# STAFF RECOMMENDATION

NCPC File No. 6479

**SMITHSONIAN INSTITUTION**  
PATENT OFFICE BUILDING  
F STREET STAIR RECONSTRUCTION AND RESERVATION LANDSCAPE  
G, F, 7<sup>th</sup>, and 9<sup>th</sup> Streets, NW

March 30, 2006

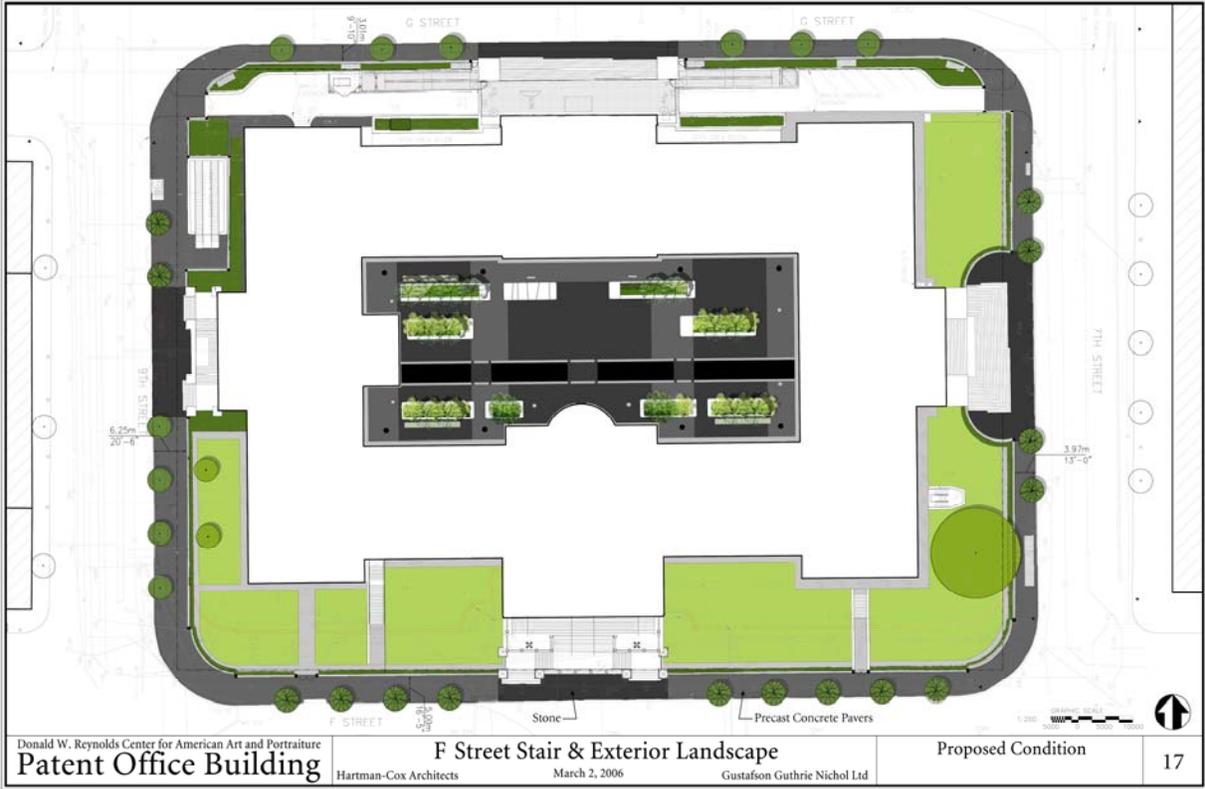
Photograph of the Patent Office and its reservation taken from the southeast in the 1870s after the F Street stair was modified following the lowering of F Street by approximately 12 feet. The historic fence will be relocated to the position shown in this photo and the south lawn will be extended behind the fence. The revised concept design for the reservation landscape proposes a simple ground treatment of grass or ground cover, with the planting of new street trees but no new trees on the grounds. The F Street stairs will be reconstructed as shown in this photograph, except that the front wall of the stairs will have three doors so that the public can enter from the sidewalk directly to the first level of the museum.
